D206-642-341BL
Job Sheet 192091

Part Name: Replacement Skidtube (Fits LH or RH)

DRAWING NO. D2650	TITLE 206/407 SKIDTUBE ASSEMBLIES	REV. F	DART AEROSPACE LTD ENGINEERING ORDER		D.E.O. NO. D2650-F-1	SHEET NO. SHEET 1 OF 1	SCALE NTS
DRAWN <i>JP</i>	CHECKED A.P.	MFG. APPR. <i>AA</i>	APPROVED <i>##</i>		DE APPR. <i>##</i>		
DATE 12.10.12	DATE 12.10.22	DATE 12.10.22	DATE 12.10.22		DATE 12.10.22

CHANGE C'BORED WELDED CROSSBOLT SPACERS TO SWAGED SPACERS

AMENDMENT TO DETAIL B
NOT TO SCALE

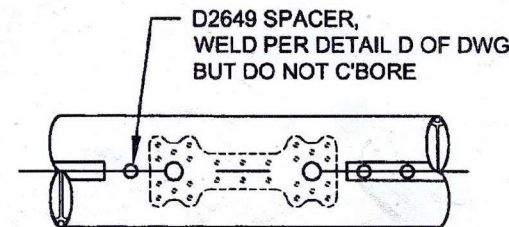
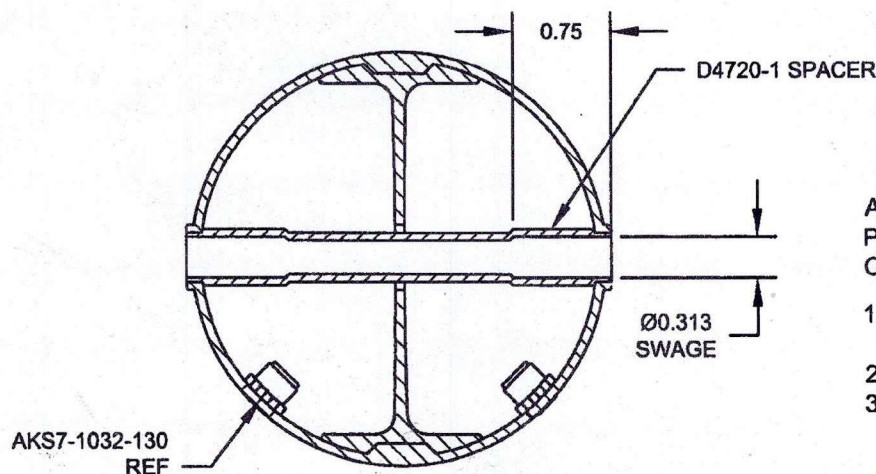
PARTS LIST IS AMENDED AS FOLLOWS:

IS:

QTY	QTY	QTY	QTY	PART NUMBER	DESCRIPTION
-1	-3	-5	-7		
1	1	0	0	D2649	CROSS BOLT SPACER
16	17	19	23	D4720-1	SPACER

WAS:

17	18	19	23	D2649	CROSS BOLT SPACER
----	----	----	----	-------	-------------------

ADD DETAIL G BELOW, WHICH IS THE SAME SECTION VIEW AS DETAIL D OF DWG.
C'BORED HOLES ARE NOW SWAGED PER DETAIL G BELOW. FOR THE Ø0.375 HOLE THAT IS NOT C'BORED, WELD PER DETAIL D OF DWG (SEE AMENDED DETAIL B FOR REFERENCE).

DETAIL G

FOR Ø0.375 HOLES ONLY
FOR HOLES THAT ARE CURRENTLY C'BORED ONLY
NOT TO SCALE

AFTER DRILLING AND BENDING ASSEMBLY
PERFORM THE FOLLOWING FOR Ø0.375 HOLES THAT ARE
CURRENTLY C'BORED:

1. INSERT D4720-1 SPACER, 16 PL (-1) OR 17 PL (-3)
OR 19 PL (-5) OR 23 PL (-7)
2. SWAGE TO Ø0.313 X 0.75 DP PER QSI 002
3. TRIM / GRIND FLUSH PER QSI 002
